SEWAGE DISPOSAL SYSTEM

MARYLAND STATE DEPARTMENT OF HEALTH

ADDRESS 2555 Jennings Chapel Road PHONE 489-4724

SUBDIVISION _____ ROAD 7020 Sanner Road LOT 3

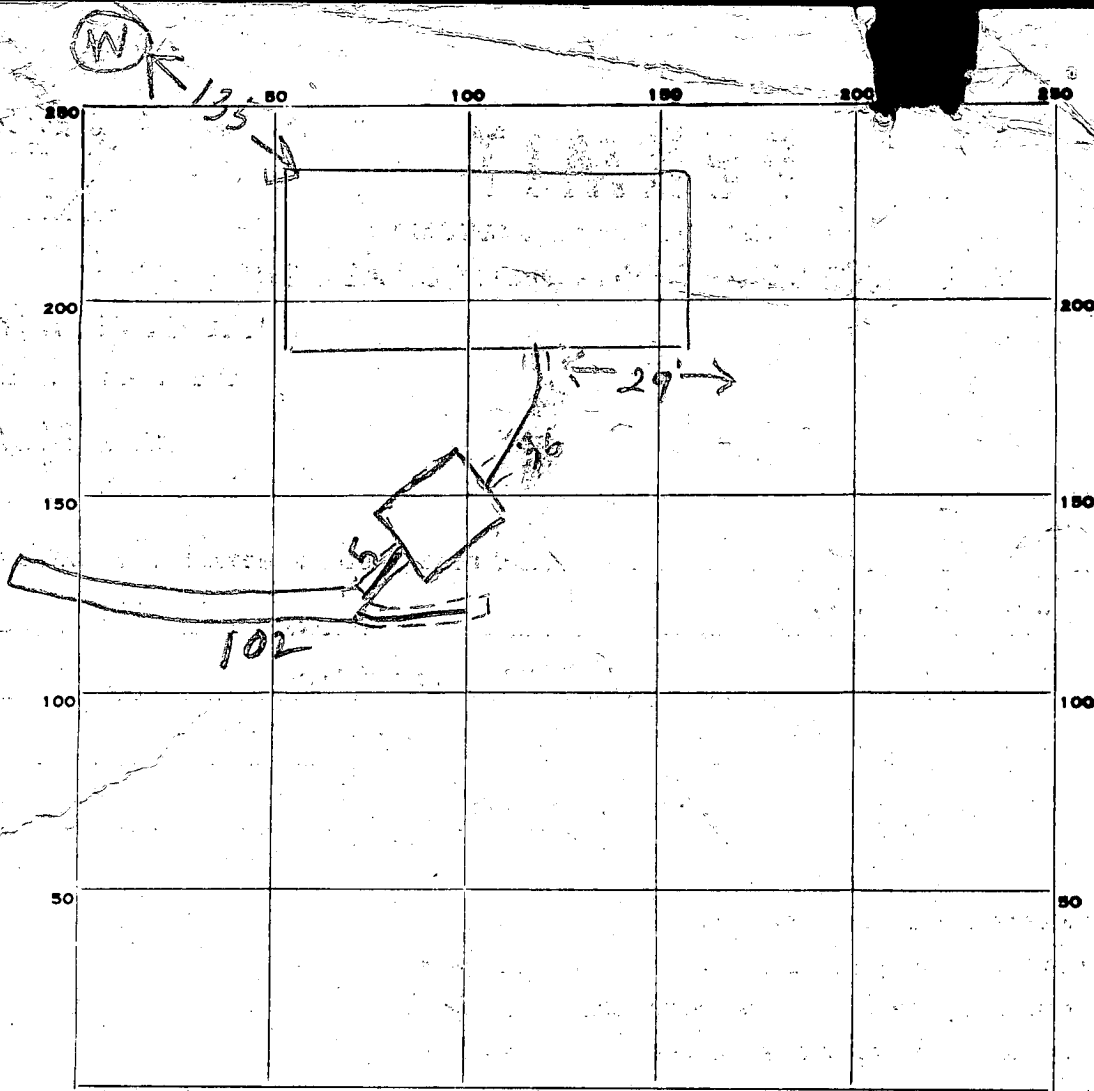
REMARKS 8/12/80 trench depth, short 9 1/2' deep
Need 8 ft more trench 10 ft deep. OK to add gravel
in 92 ft trenches. SK & JH
8/15/80 - STONE ADDED

Sanner Rd

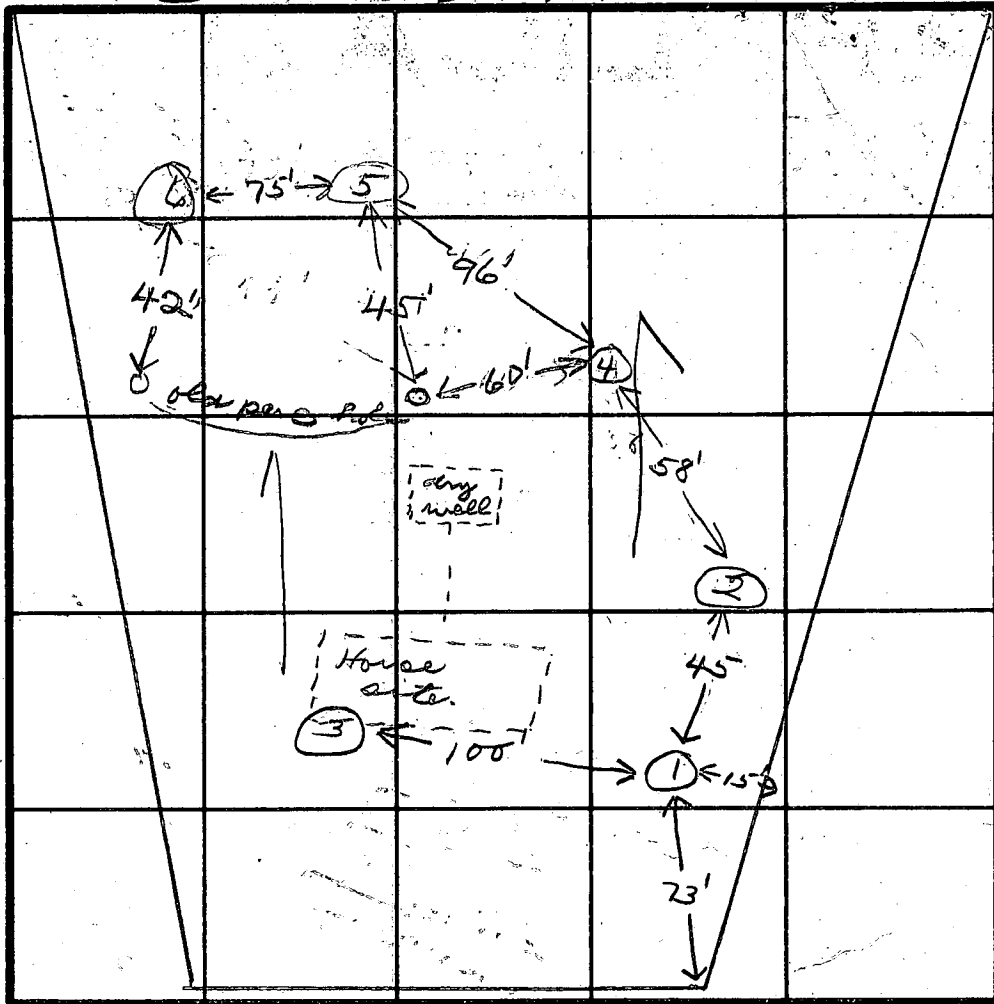
REASONS FOR REJECTION OR HOLDING 11/31/80 hold for review with FF

Mr. Gaskill says he will make appointment with new plat

New spec's will also have to be written. JS

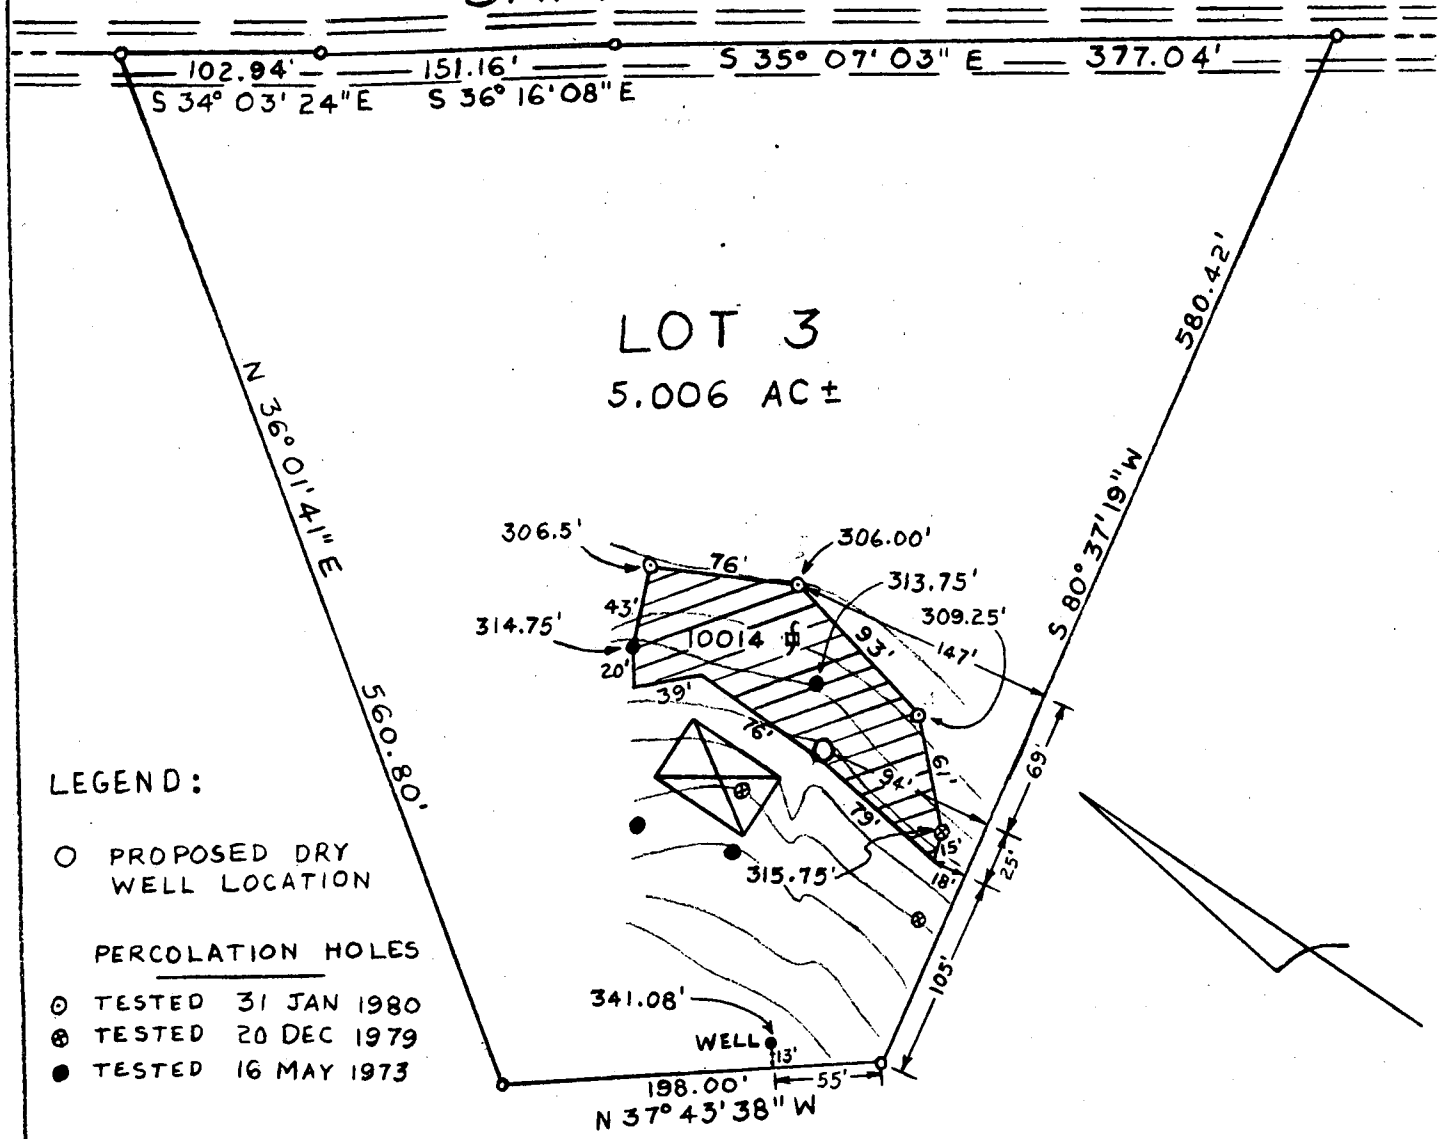
- ① 70 FT CASING 1 FT OUT OF GROUND
- ② OPEN HOLE 57 FT DEEP MEASURED WITH A STRING
- ③ PERC HOLES OVER 100 FT FROM WELL
& LOWER PER BOB GASKILL OWNER (PRESENT TODAY)
- ④ 10 BAGS SO FAR HAD TO LEAVE,
- ⑤ ON 2/6/80 SOME ONE CALLED & SAID 19
BAGS USED

SITE PLAN
SCALE 1" = 50'

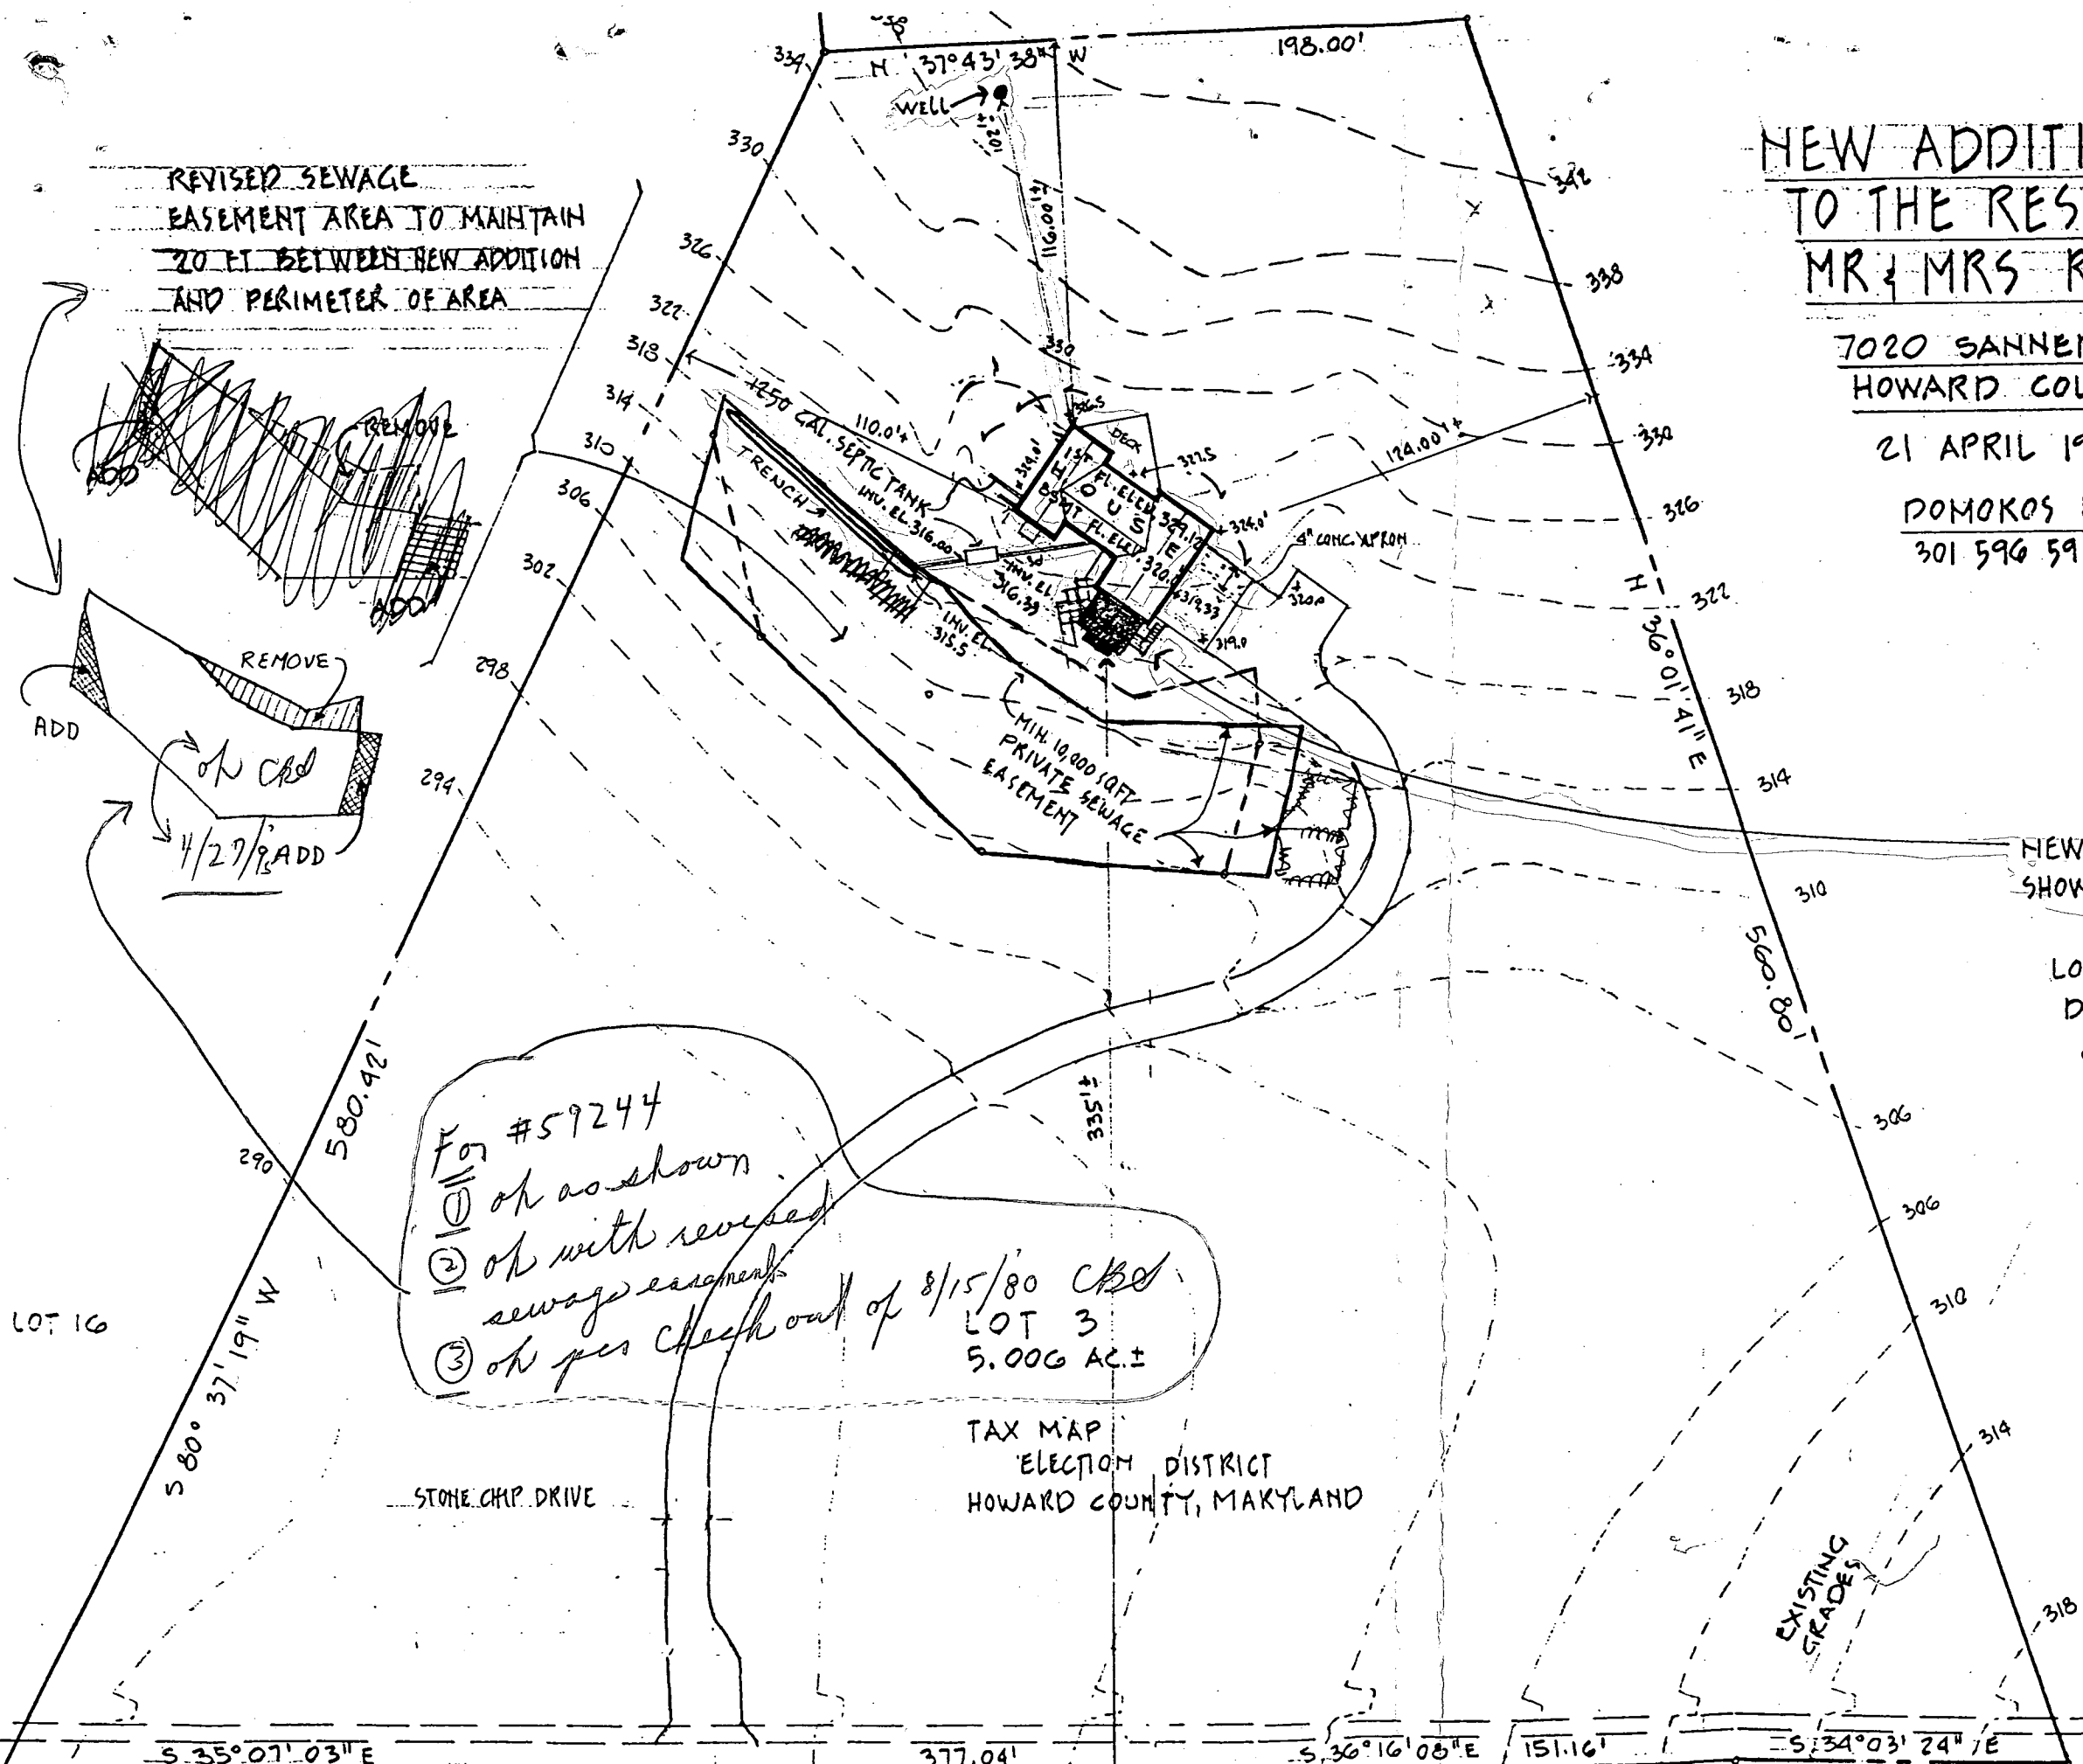
REVISED SEWAGE
BASEMENT AREA TO MAINTAIN
20 FT BETWEEN NEW ADDITION
AND PERIMETER OF AREA

For #59244
① ok as shown
② ok with revised
sewage easement
③ ok per check out of 8/15/80 C&D
LOT 3
5.006 AC ±
